CITY PLAN COMMISSION STAFF REPORT

Woodhaven

Item	Case	Request
7	CD-CPC-2021-00216	Rezoning to MPD

Plan Conditions, Corrections, & Recommendations Report

COVER SHEET

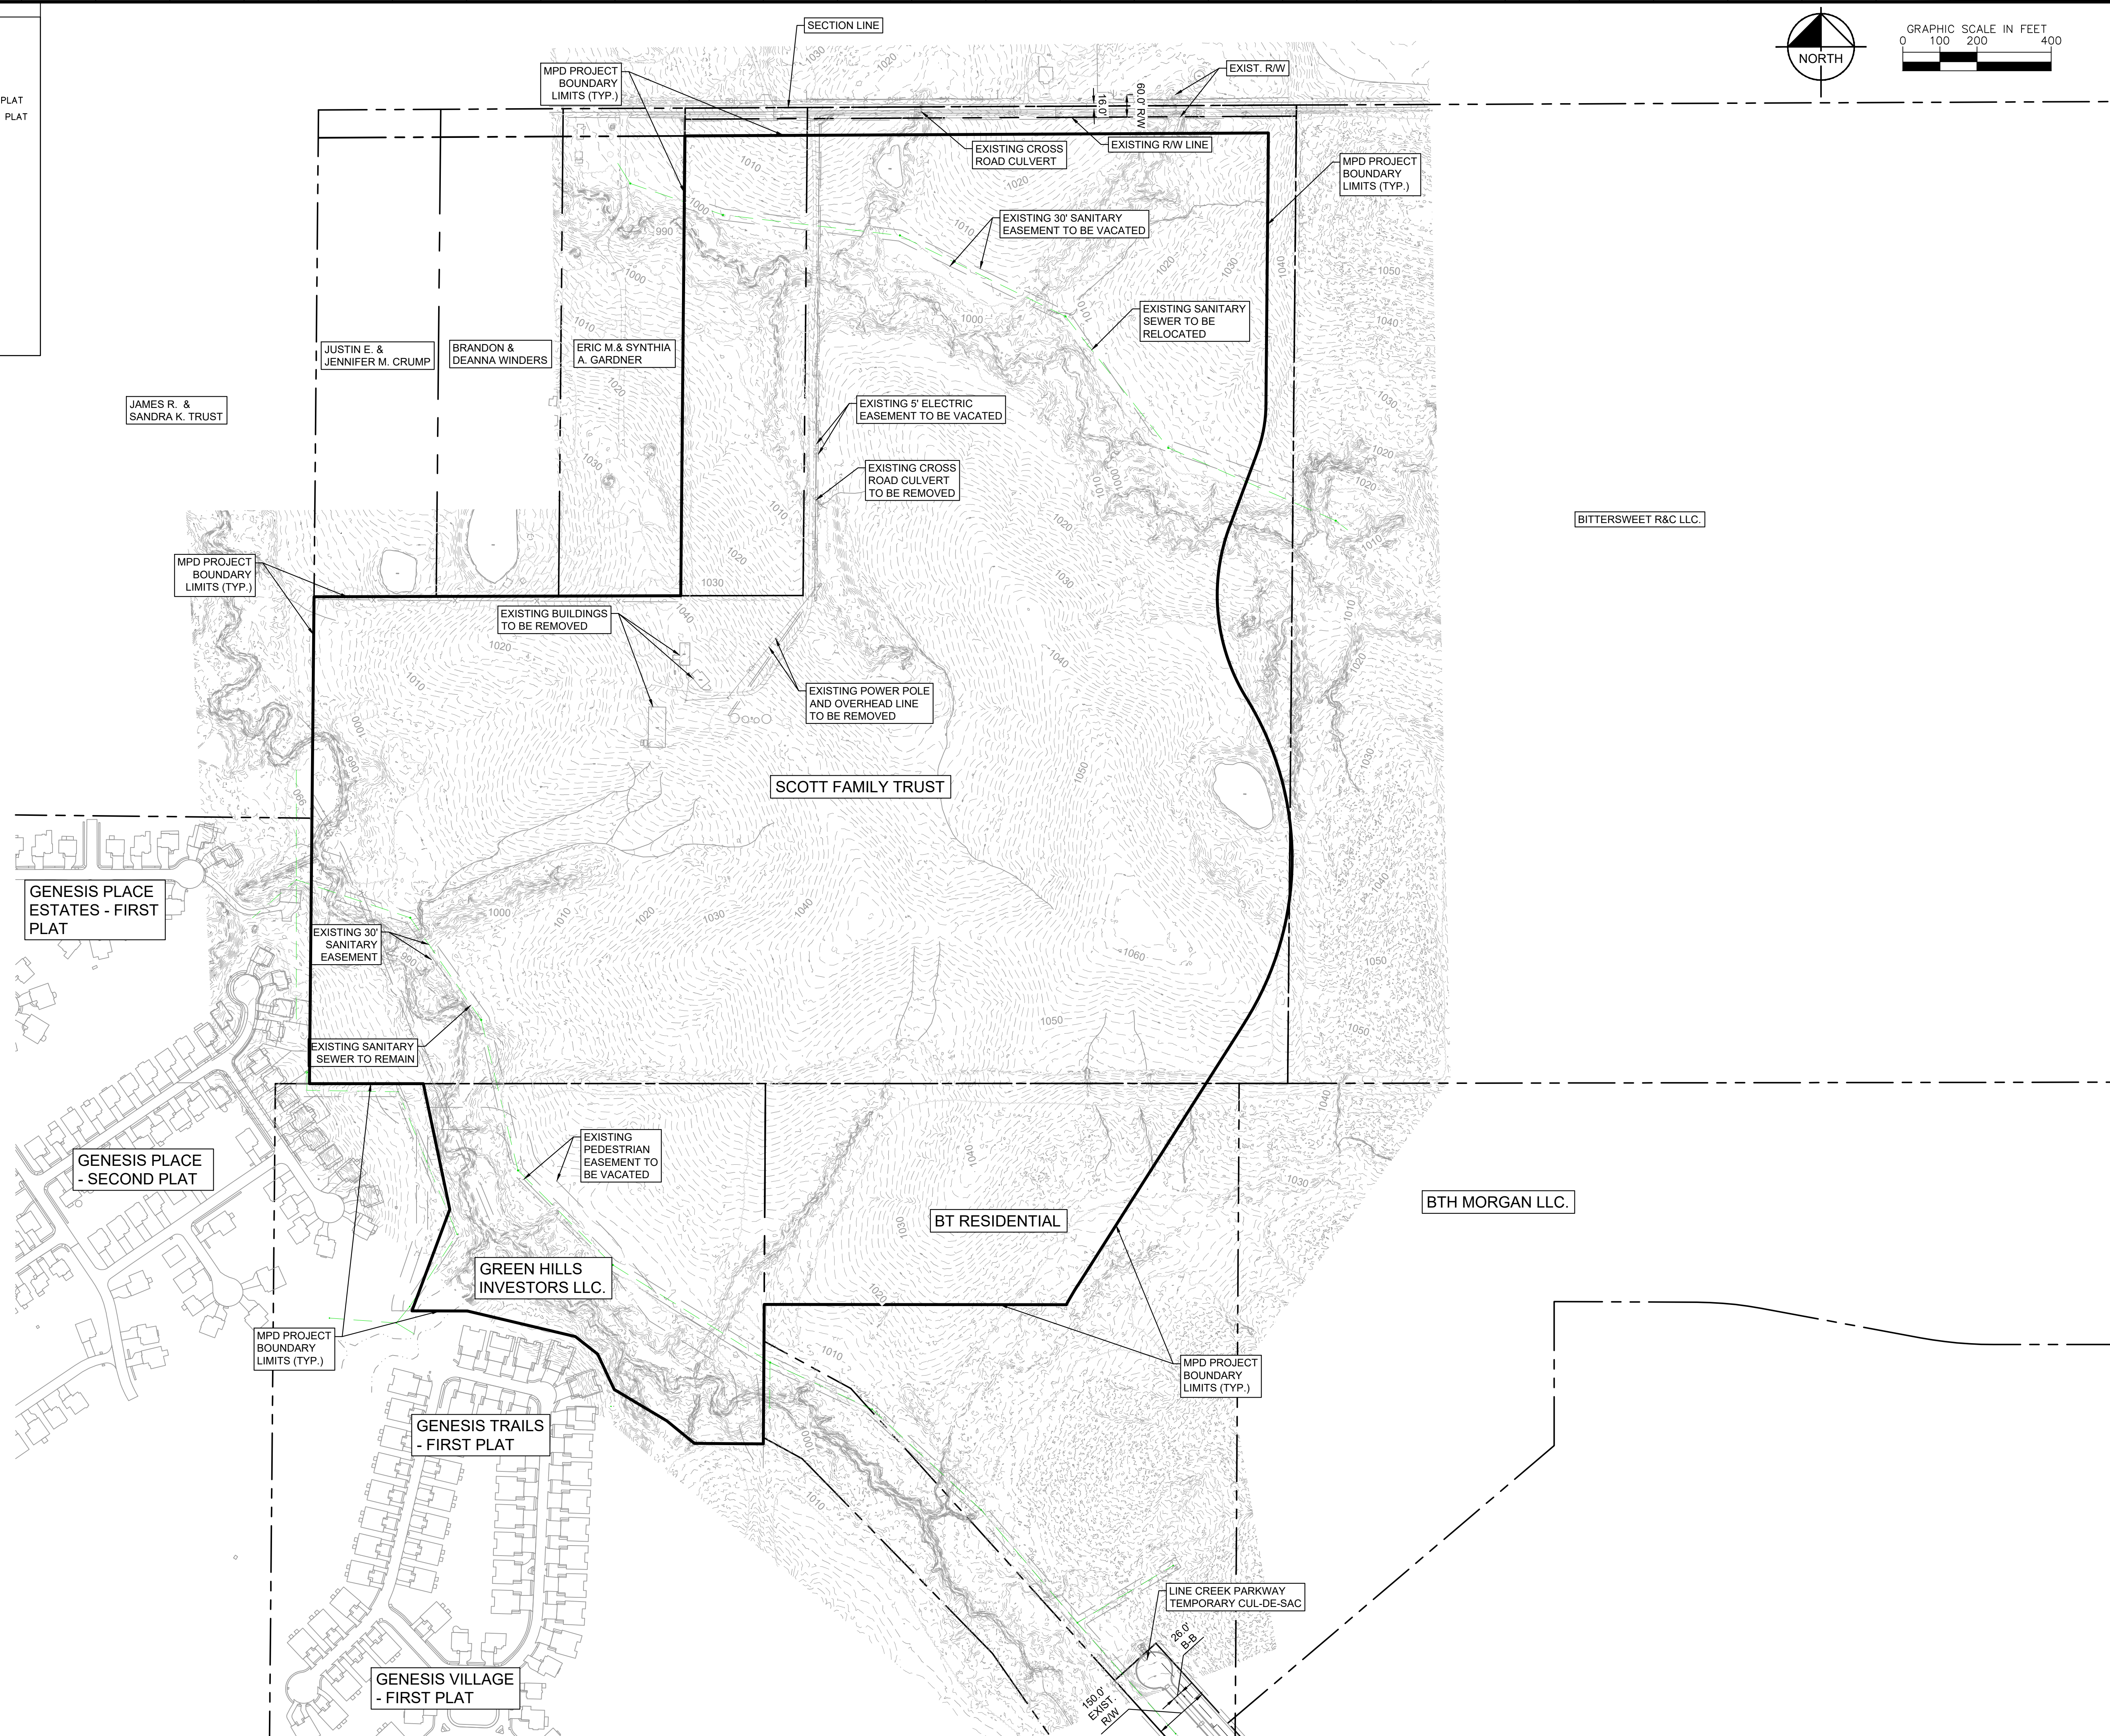
5. Provide written justification as to why the proposed infrastructure requirement shown in deviation number 1 on the cover sheet creates an undue financial burden on the applicant. Provide geotechnical information regarding the existing soil conditions on the proposed development site and the subgrade recommendations of a licensed professional engineer specializing in the design of pavement sections. UPDATED 1/10/22 - no geotechnical information provided as requested to support deviation is in the best interest of the City. (1/03/2022)

6. Provide written justification as to why the proposed infrastructure requirement shown in deviation number 7 on the cover sheet creates an undue financial burden on the applicant. Provide supporting documentation as to why reduced lighting levels within the residential areas still provide adequate levels of security. UPDATED 1/10/22 - no documentation provided to support why deviation is in the best interest of the City. (1/03/2022)

10. Sheet C0, Deviation No. 3: Standard drawings and specifications for proposed alternatives must be provided for consideration. If a deviation is allowed, these items will need to be included as part of the approved documents.
Updated Comment (2022-01-12): Internal discussions regarding this deviation are ongoing. At this time, a determination has not been made with regard to acceptability of this deviation. (1/03/2022)

12. Remove Item 5 from the MPD List of Public Infrastructure Deviations for Woodhaven Subdivision from Cover sheet and all future plan sheets,
per the KC Water Rules and Regulations for Water main extensions and Relocations.
(<https://www.kcwater.us/wp-content/uploads/2019/04/2018-Rules-and-Regulations-for-Water-Main-Extensions.pdf>)

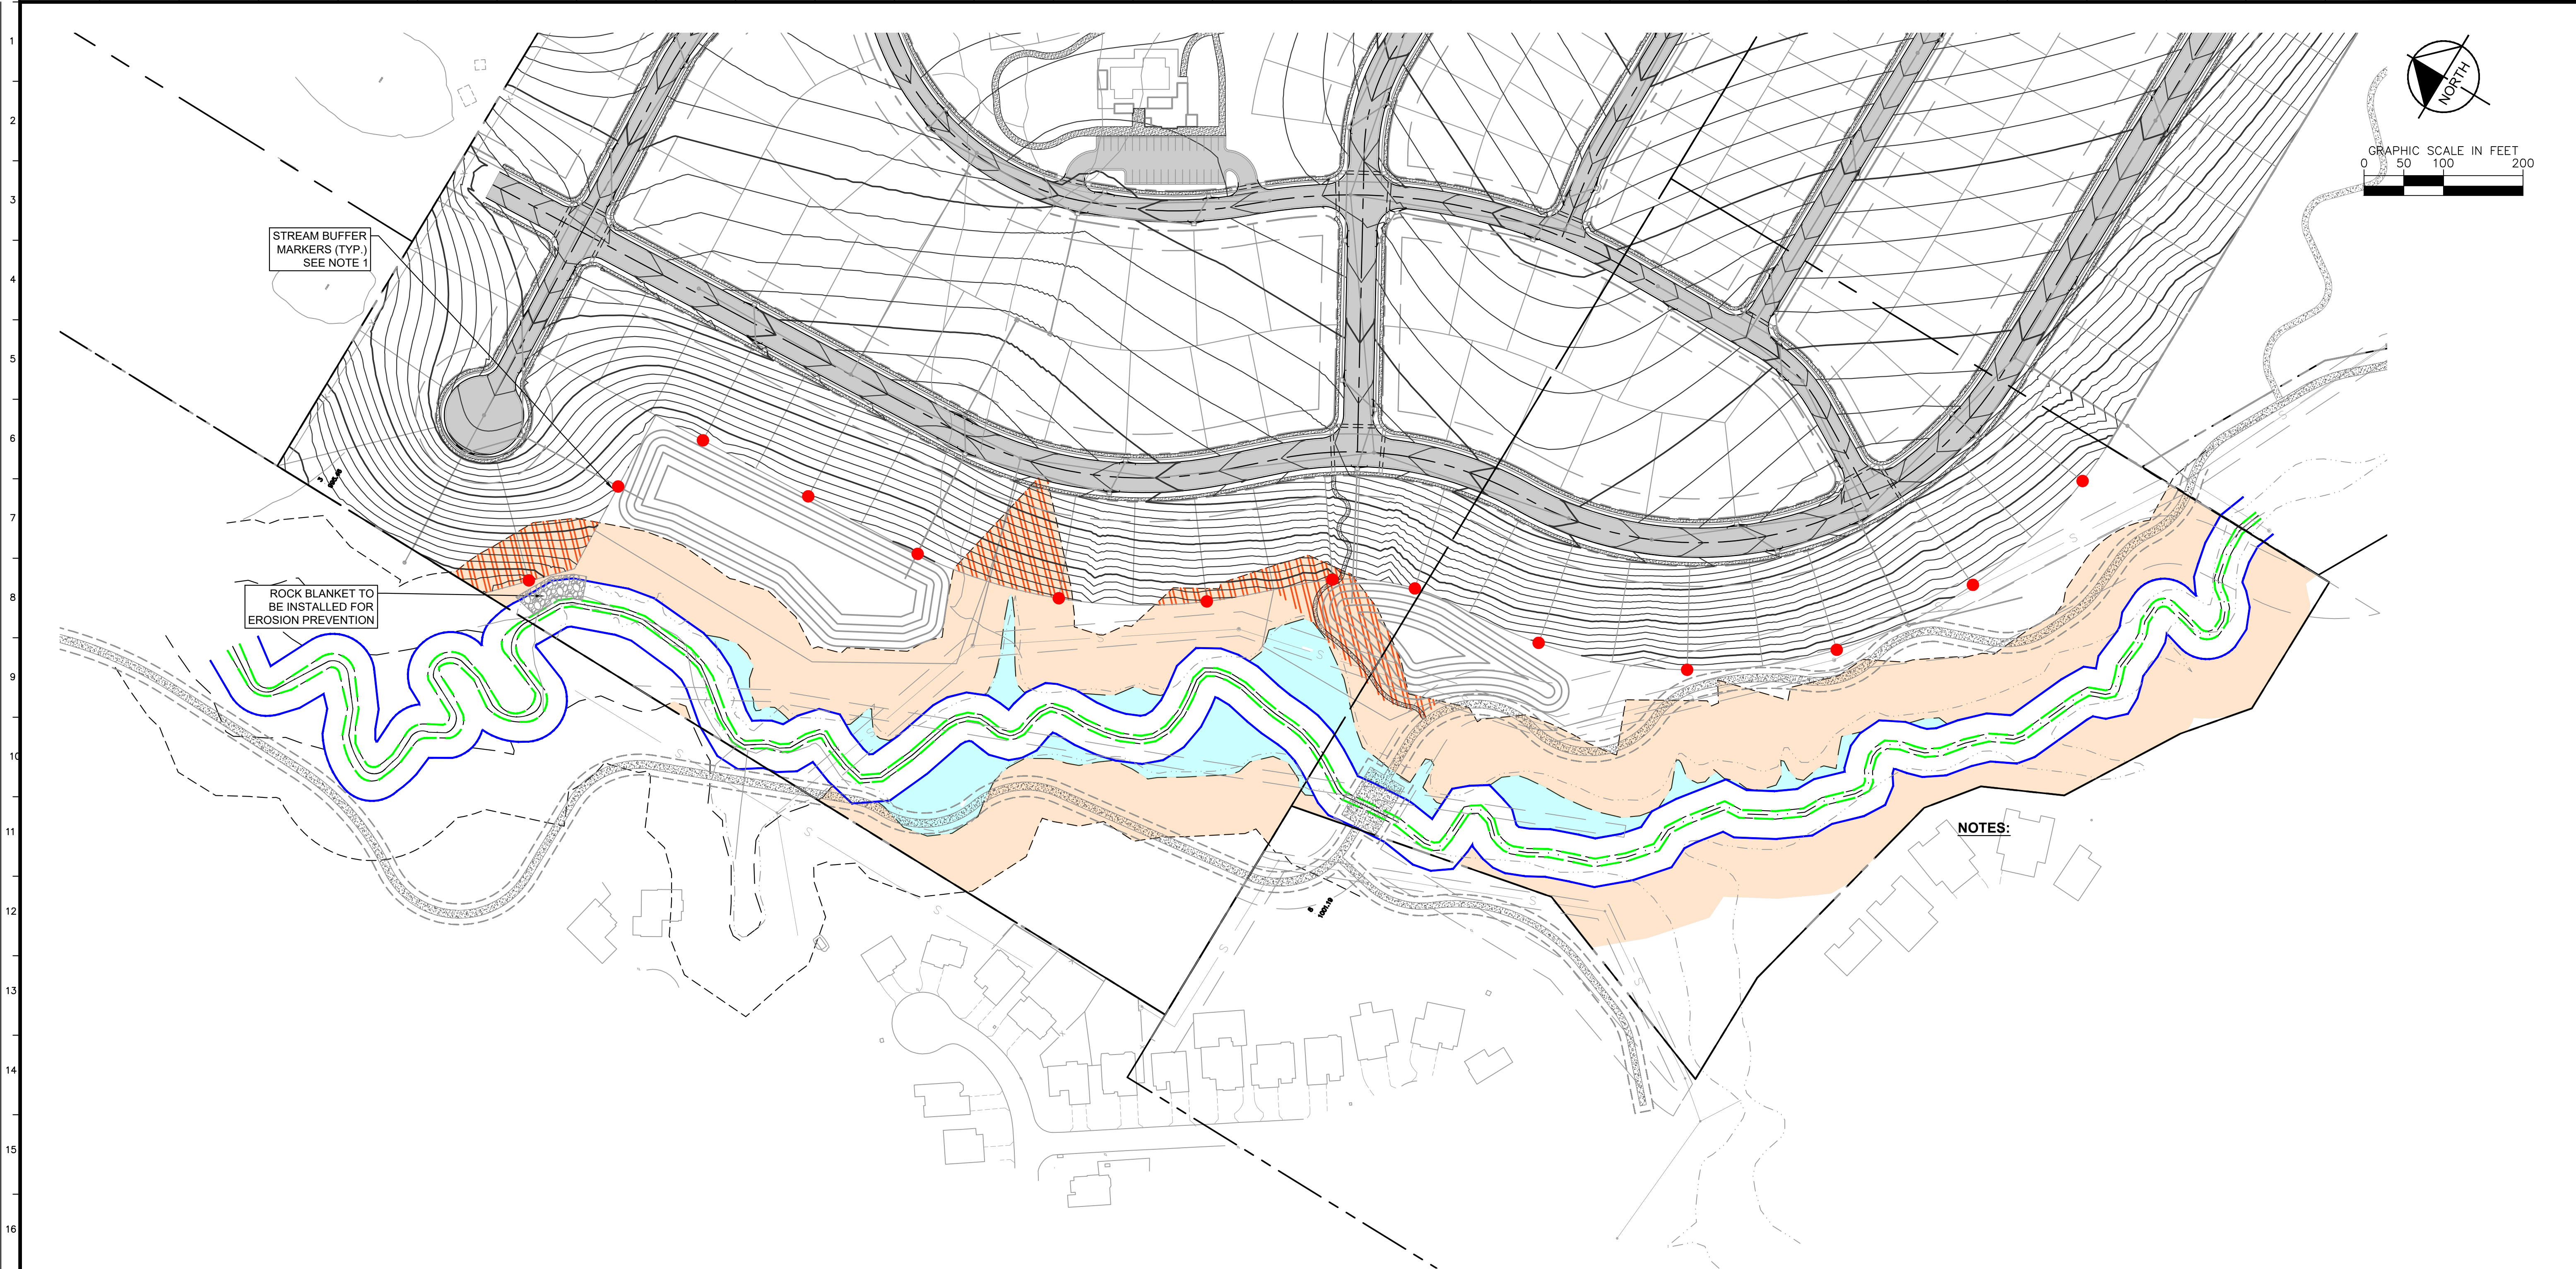
2. Stream buffer plan does not include all of the information required as part of Section 88-415. UPDATED 1/10/22 - no revisions made to the stream buffer plans as part of the resubmittal. (1/03/2022)

11. Stream buffer plans do not meet requirements of 88-415. Fill in middle zone is not allowed except for allowed uses. First twenty-five feet of outer zone is no-build area. There is risk for embankment failures due to proximity of fill slopes to streams--this must be addressed through erosion hazard and slope stability analyses.
Updated Comment (2022-01-12): Fill in middle zone is not allowed for detention ponds. Proposed fill will reduce the natural storage in floodplain areas and could increase flood elevations. Storage in ineffective flow areas helps to attenuate peak discharges downstream, since it is essentially acting as a natural detention area. Provide a minimum of 25 feet (no-build area per 88-415-5-C.2.c) from edge of middle zone to any improvements, including embankment fill. Remove proposed "rock blanket for erosion prevention"--this is not acceptable and in all likelihood will induce stream instability issues. (1/03/2022)
